Access Compliance Report

Public Rights-of-Way

Intersection ID: 23481	Main Street: ALEXANDER_RD	Cross Street: PROVIDENCE_RD	Location: NW
ADA ID: B86AEF638869	Ramp Type: Perp	Initial Pass/Fail: Fail	Overall Compliance: No
Severity Score: 22.5			
Codes/Mitigation Info/Possible Solution		Field Measurements/Component Compliance

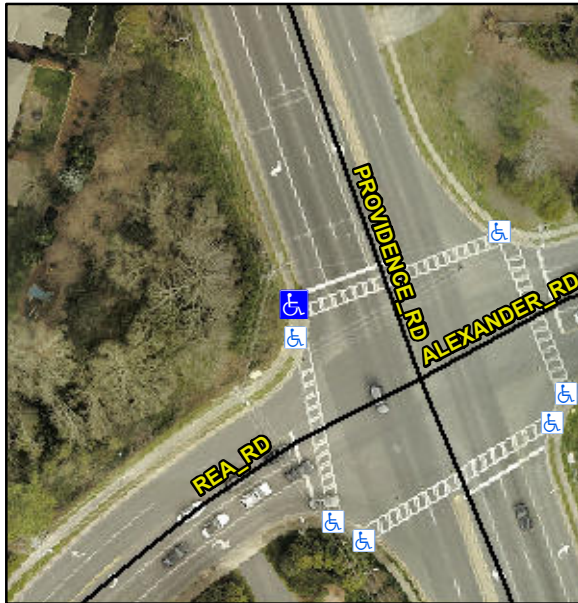
Not Found, R304.5.1, R304.2.2, R304.5.3

Compliance	Description	Data	Compliance	Description	Data
N/A	Ramp Length (in)	78.0	No	Ramp Slope (%)	10.1
No	Ramp Width (in)	44.0	No	Ramp XSlope (%)	3.9
N/A	Flare Type LT	N/A	N/A	Flare Type RT	N/A
N/A	Flare Slope LT (%)	N/A	N/A	Flare Slope RT (%)	N/A
N/A	Flare Traversable LT?	N/A	N/A	Flare Traversable RT?	N/A
N/A	Landing Length (in)	N/A	N/A	DWS Provided?	N/A
N/A	Landing Width (in)	N/A	N/A	DWS Contrast?	N/A
N/A	Landing Slope (%)	N/A	N/A	DWS Length (in)	N/A
N/A	Landing X Slope (%)	N/A	N/A	DWS Full Width?	N/A
N/A	Landing Curb? (Y/N)	N/A	N/A	DWS Offset (in)	N/A
N/A	Shared Landing?	N/A			
N/A	Gutter Ponding?	N/A	N/A	Gutter Slope (%)	N/A
N/A	Gutter Lip Ht (in)	N/A	N/A	Gutter X Slope (%)	N/A
N/A	Painted X Walk1?	Yes	N/A	Painted X Walk2?	N/A
	X Walk 1 Direction	To E		X Walk 2 Direction	N/A
N/A	X Walk 1 Width (in)	65.0	N/A	X Walk 2 Width (in)	N/A
	X Walk 1 Slope (%)	0.7		X Walk 2 Slope (%)	N/A
	X Walk 1 X Slope (%)	1.0		X Walk 2 X Slope (%)	N/A

Remove & Replace Entire Ramp.
